DUKE COGEMA
STONE & WEBSTER

18 February 2003
DCS-NRC-000128

Subject: Docket Number 070-03098
Duke Cogema Stone & Webster
Mixed Oxide Fuel Fabrication Facility
Responses to Financial Qualification, Fire Safety, Chemical Safety, Aqueous
Processing, Material Processing and Ventilation Open Items/Additional NRC
Questions on Construction Authorization Request (CAR) Revision

Responses to Financial Qualification, Fire Safety, Chemical Safety, Aqueous Processing, Material Processing and Ventilation Open Items/Additional NRC Questions on Construction Authorization Request (CAR) Revision

Evaporation Rate of a 50m² Pool of 13.6N Nitric Acid at Various Wind Speeds

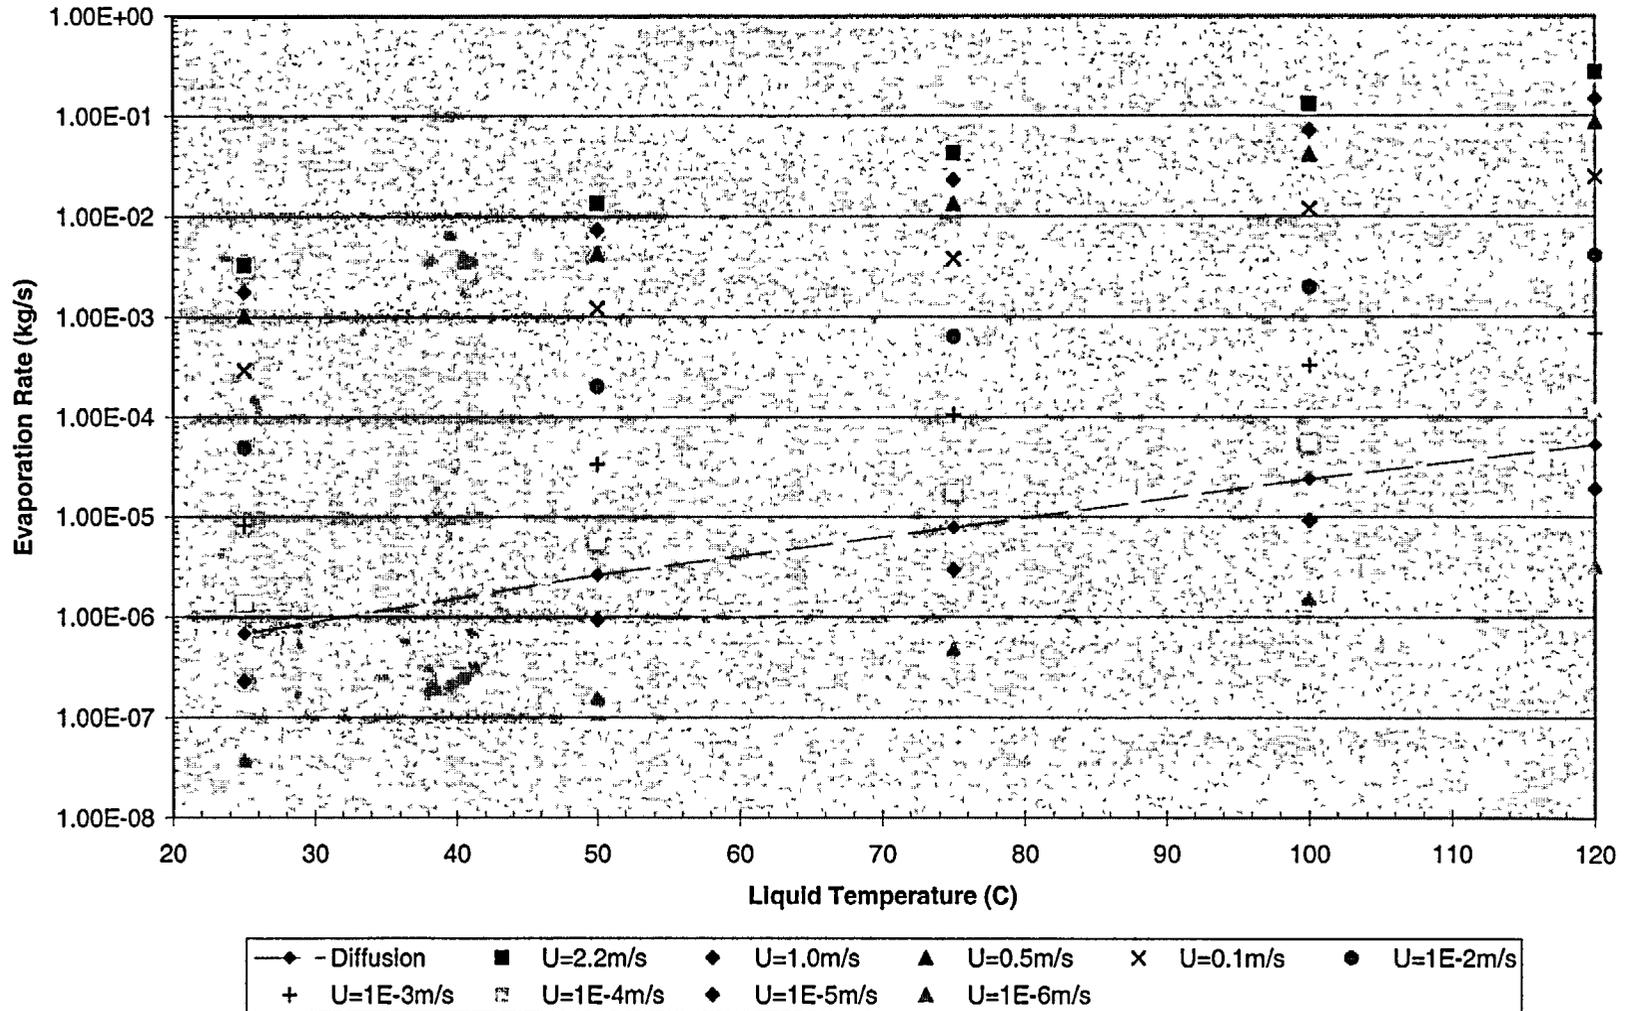
In a 22 January 2003 telecon, NRC requested information on the calculation approach used for evaluating the effects of indoor nitric acid spills to an external receptor (specifically, the applicability of the model at low wind speeds and if assumptions on wind speed were a design basis). The scoping studies of releases of nitric acid were performed at elevated temperatures from within the MFFF building to determine the impact to the site worker at 100 meters. The study modeled several releases under a variety of conditions and included parametric studies of nitric acid temperature and concentration, amount of material involved in the spill, size of the spill/room, and indoor wind speed. The 95th percentile outdoor X/Q was used to transport the release once the release reached the outside of the building. No credit was assumed for building holdup, dilution within the ventilation system, or cooling of the spilled solution to the

A final check was performed to assure that the diffusive evaporation rate (occurring at zero wind speed) did not exceed the evaporation rate produced by the ALOHA model at low wind speeds for high concentration nitric acid (13.6 N) at an elevated temperature of 120 °C. The attached figure shows that very low wind speeds ($< 10^{-4}$ m/s) are required to reach evaporation rates comparable to the diffusive evaporation rate.

This information indicates that the evaporation rate model used to assess the chemical consequences of leaks and spills inside the aqueous polishing building is applicable for the evaluated low indoor wind speeds.

Flammability Limits of Argon-Hydrogen in Air at 1 bar and temperatures as shown
Data from Chemsafe (C) DECHEMAe V.14 10 2002

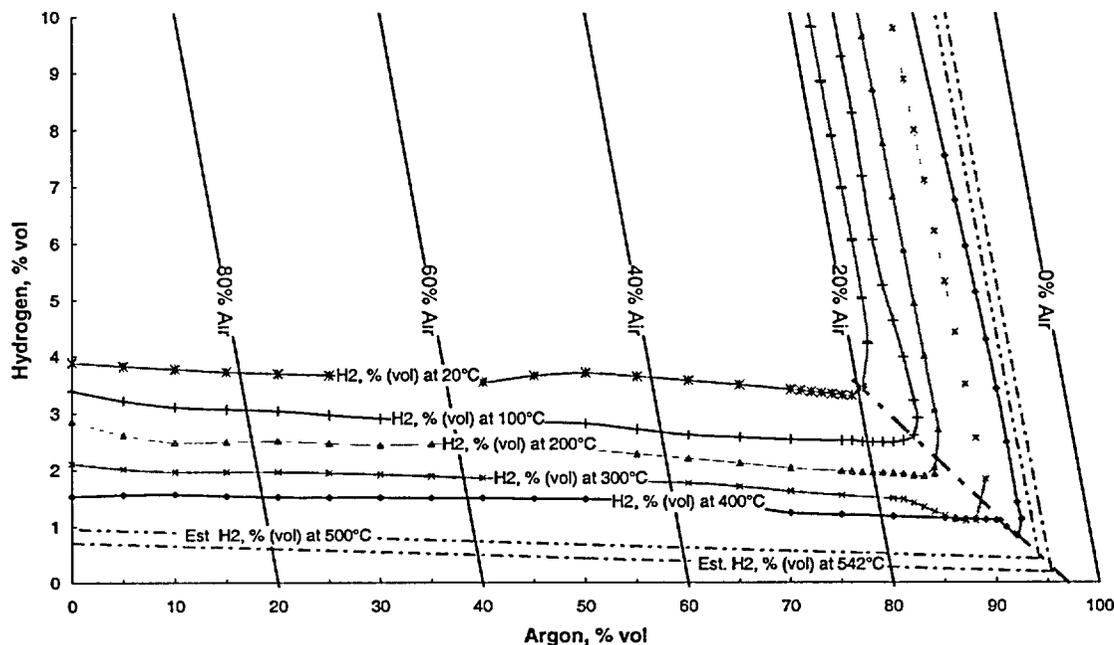
Clarification of AP-02: Provide the lower flammability limit methodology and a Hanford report that supports the use of acid normality controls as design bases, as described at CAR 5.5.2.4.6.13.

The concentration of argon is shown on the abscissa (x-axis). The corresponding hydrogen concentration is the ordinate value at the point that the argon concentration value intersects the flammability limit line. Thus at 0% argon, the figure shows that the LFL for hydrogen at 20°C is 4% by volume (i.e., the standard value). At elevated temperatures, say 120°C, which could be the result of an accident, the LFL could be as low as 3.3% hydrogen by volume, when the gas composition also consists of 75% argon and 21.7% air. Because this scenario represents the worst case credible environmental conditions for a leak of the hydrogen-argon gas into the sintering furnace room, the LFL thresholds for this scenario would be set at 1.6% (50% LFL) and 0.8% (25% LFL).

For diluents other than argon, such as water vapor or steam, the LFL values actually increase with increases in the diluent concentration. For these cases, the conservative assumption would assume the LFL for pure hydrogen in air and the standard value of 4% by volume would be used as the LFL. The thresholds would be 2% (50% LFL) and 1% (25% LFL). This value would be
